Re: Metro-North Commuter Railroad Company
Harmon Railroad Yard, Croton-on-Hudson, NY
Final Operable Unit I Operations and Maintenance Plan

*Harmon Railroad Yard
Croton-On-Hudson, New York*

**Re: *Harmon Railroad Yard Site, Operable Unit II
NYSDEC Site No. 3-60-010
Response to NYSDEC Comment Letter on O&M Manual***

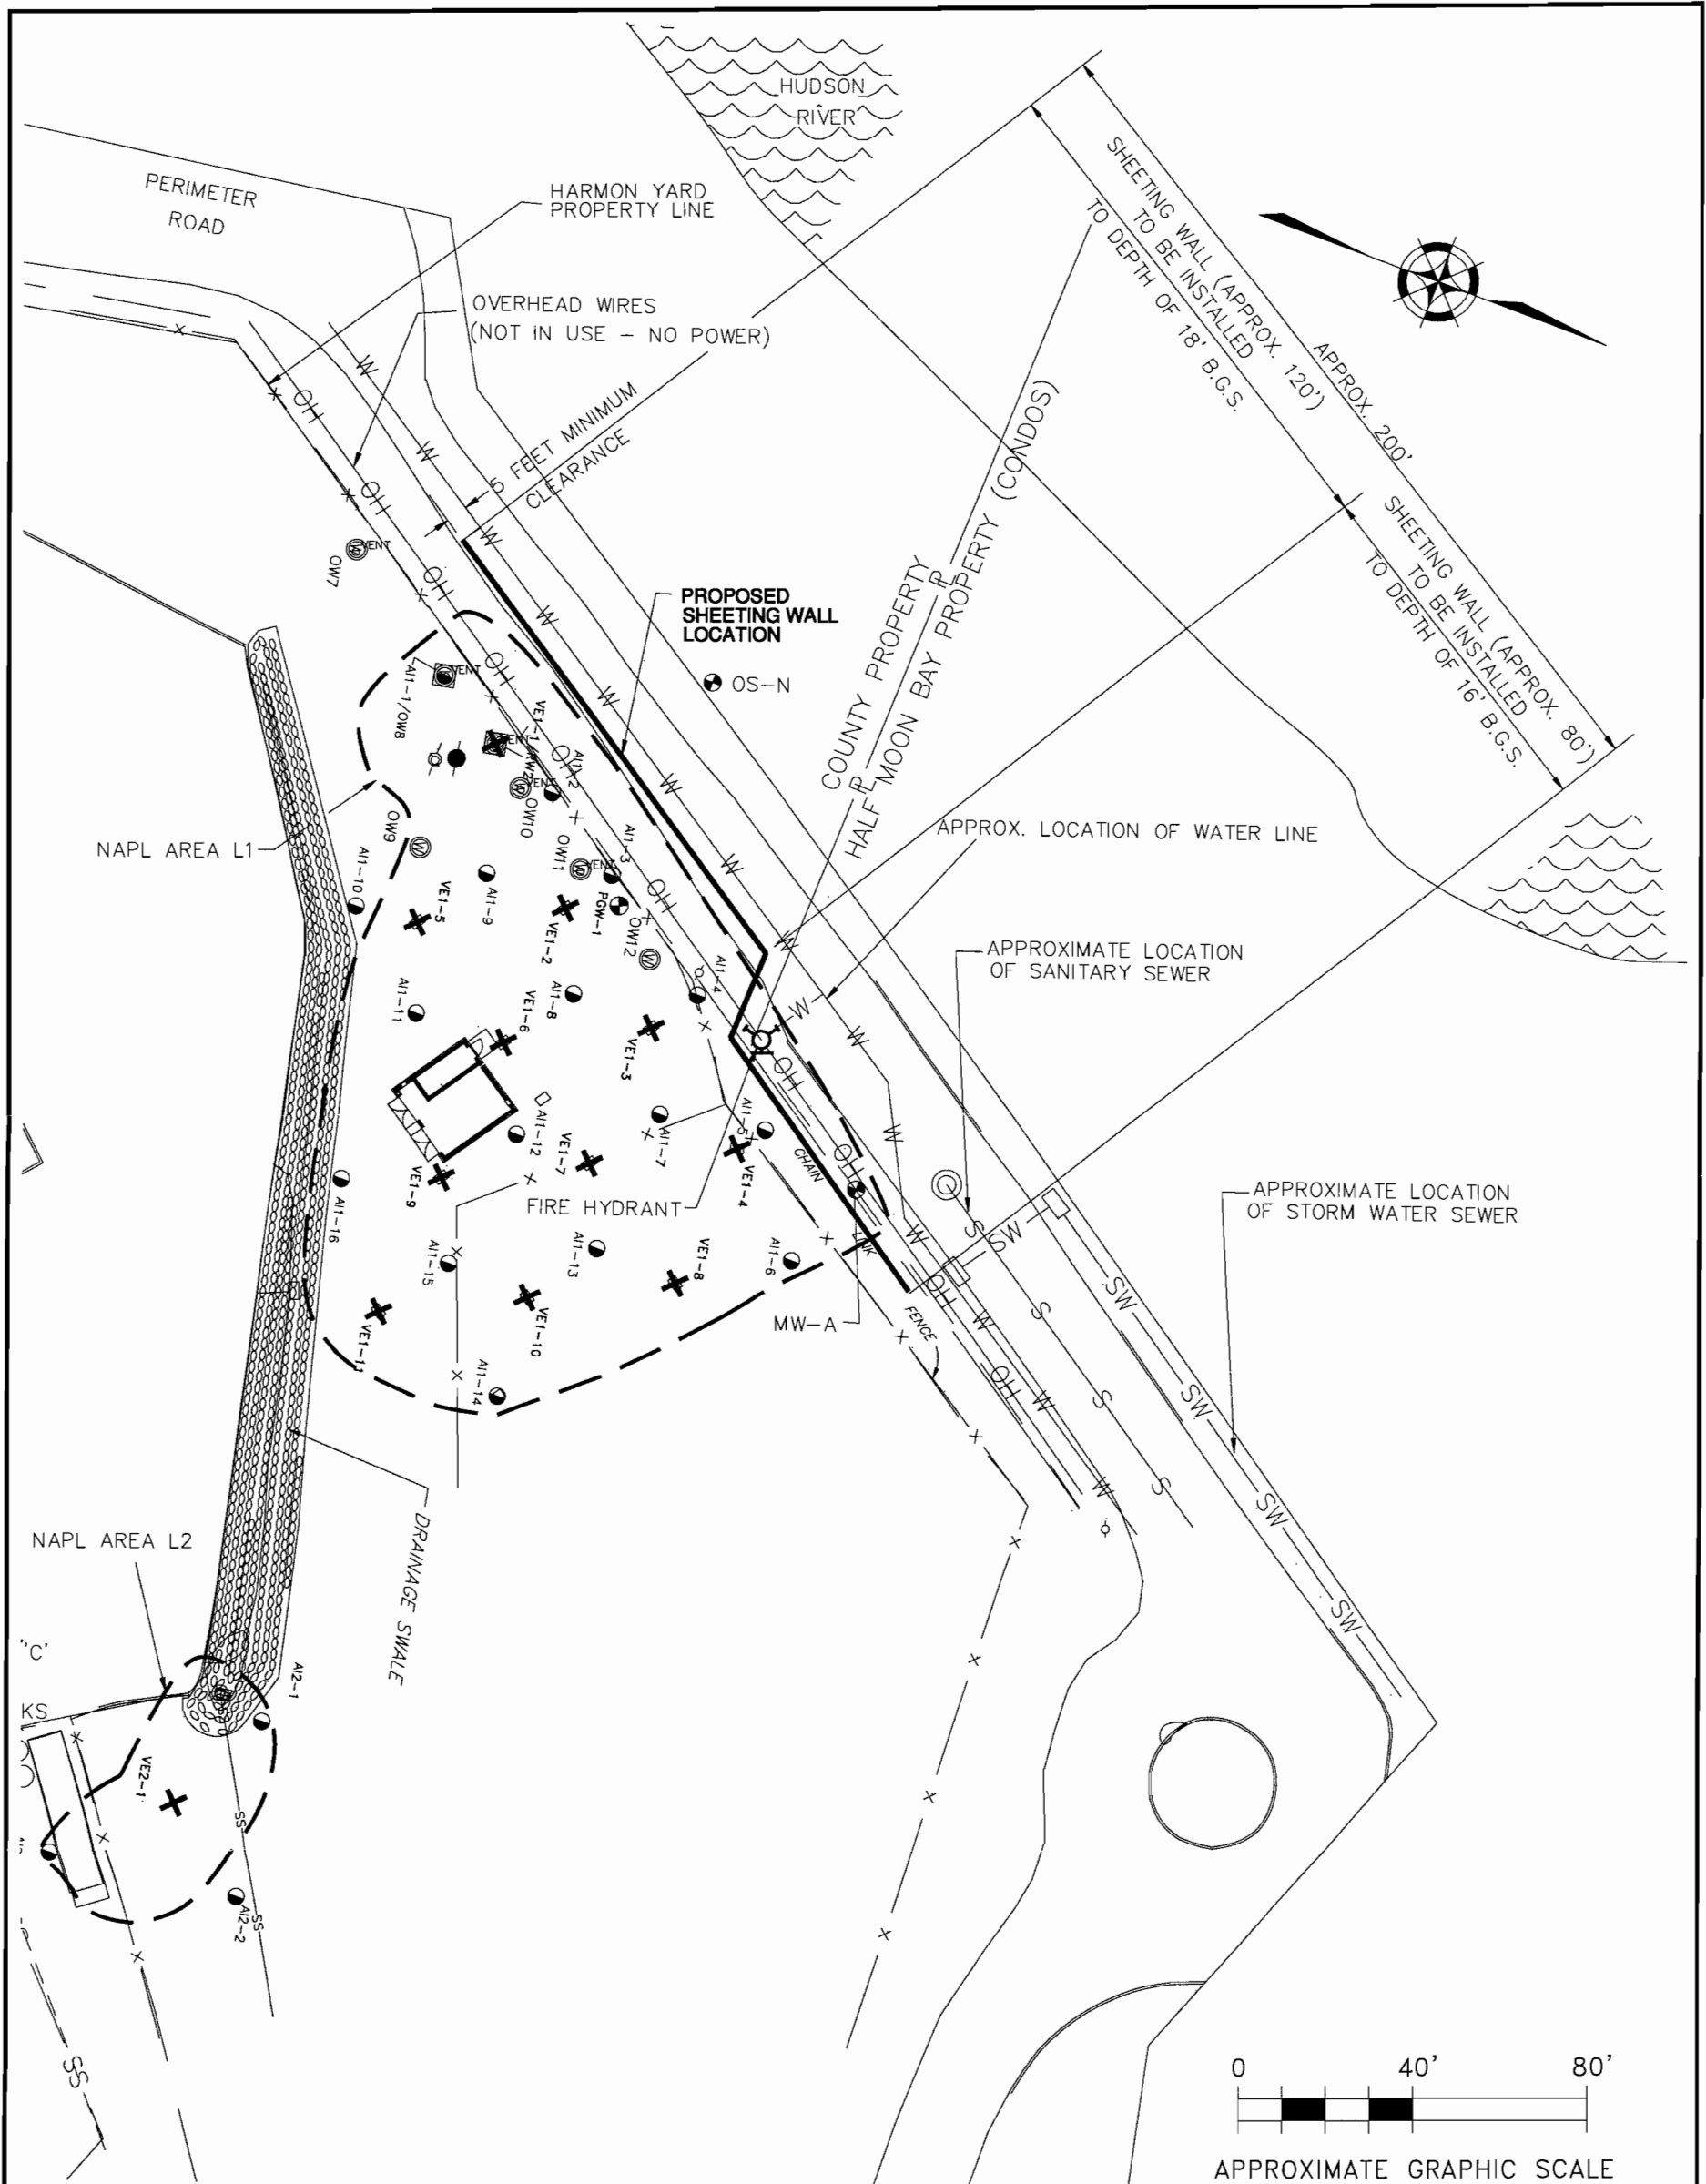
The following describes the minor changes that will be made to the depth and location of the NAPL Area L1 sheeting wall at the OU-II Site, as shown on Figure A.

SHEETING WALL LOCATION CHANGES – The location of the OU-II sheeting wall identified in the RI/FS and in the final design was a straight-line installation along the northwest boundary of the Harmon Yard property boundary near NAPL Area L1. The sheeting wall was to have been installed between Harmon Yard and the road located near the perimeter of two properties adjacent to Harmon Yard. As shown on Figure A, this road is located next to Harmon Yard and at the edge (perimeter) of these two adjacent properties. Hence, it is referred to in this memorandum as the perimeter road. The sheeting wall, then, was to have been installed adjacent to the perimeter road and on these two adjacent properties.

ERM addressed this conflict by altering the configuration of the sheeting wall in this northern area. As shown on Figure A, the northern 80-foot length of the 200-foot sheeting wall will be relocated about 20 feet closer to Harmon Yard. This 80-foot northern section of the sheeting wall will be installed on Harmon Yard property. The location of the southern 120-foot length of the sheeting wall will remain the same, i.e., at the edge of the perimeter road. This 120-foot southern section of the sheeting wall

will be installed on the adjacent off-site property. None of the OU-II sheeting wall will be installed on the adjacent property that is located in the northern section of the sheeting wall, although access to that property will probably be needed during installation. As shown on Figure A, two 60° angles and a 20-foot additional length of sheeting wall have been included in the new sheeting wall configuration to connect the southern and northern portions of the sheeting wall. The reconfigured sheeting wall will provide a continuous physical barrier to NAPL migration from Area L1.

SHEETING WALL DEPTH CHANGES - As discussed above, the configuration (horizontal location) of the OU-II sheeting wall was revised to address the presence of a water supply line in the northern (i.e., Half Moon Bay) area. In addition, there is a slight (i.e., 2-foot to 4-foot) rise in the topography (surface elevation) from Harmon Yard to the surface of the perimeter road. ERM collected information on the depth to groundwater along various sections of the sheeting wall to determine whether the depth of the sheeting wall should be modified to address the revised configuration and the elevation difference between Harmon Yard and the perimeter road. As defined on Drawings C-3 and C-7 of the final design (contract documents), the design called for the sheeting wall to be installed to a depth of 16' below ground surface throughout its 200-foot length. ERM collected the following depth to groundwater information in September 2001 to determine whether the sheeting wall depth should be modified:

Sheeting Wall Depth in the Northern Section - OU-II Sheeting Wall – The northern section of the sheeting wall is to be installed on the NAPL Area L1 section of the Harmon Yard OU-II Site. The surface of NAPL Area L1 is relatively flat and the groundwater depth information collected from the on-site wells OW-11 and OW-12 are indicative of groundwater depth conditions across this area. As shown in the table presented earlier in this memorandum, the depth to groundwater in these two on-site monitoring wells measured in September 2001 was approximately 8.0 feet below ground surface. Based on this information, the depth of the sheeting wall in this northern section of the sheeting wall will remain at 16 feet below ground surface. This will extend the sheeting wall to at least 8 feet below the water table in this area. This sheeting depth is more than adequate to address normal water table fluctuations and prevent the potential migration of NAPL to off-site areas in the future. As stated above, the September 2001 water table data collected by ERM and used in this analysis addresses the potential changes in water table elevations that may occur due to seasonal variations and tidal fluctuations.

The changes to the depth and location of the OU-II sheeting wall are minor changes to the OU-II remedy. These changes were compared to the three criteria identified in the NYSDEC TAGM #4059 (i.e., scope, performance and cost) to demonstrate that these changes are minor and will have little or no effect on the OU-II remedy.

SCOPE – These changes do not affect the scope of this component of the OU-II remedy. The reconfigured sheeting wall is still a 200-foot long physical barrier installed 3 to 8 feet below the water table that will provide a continuous barrier to NAPL migration from the OU-II Site. There are no changes to the concept or the technology involved in this component of the remedy.

PERFORMANCE – These changes will not affect the performance of the remedy. The NAPL in Area L1 will still encounter a physical barrier and will not be able to migrate to the Hudson River. The reconfigured sheeting wall will not adversely affect the vacuum enhanced NAPL removal system that has been installed to remove OU-II NAPL.

SUMMARY: SHEETING WALL MODIFICATIONS ARE MINOR CHANGES – As discussed above, the depth and location changes to the OU-II sheeting wall will have little to no effect on the scope, performance and cost of the OU-II remedy. As a result, these sheeting wall modifications are minor changes to the OU-II remedy and need only be documented with a project file memorandum. This memorandum constitutes that documentation.
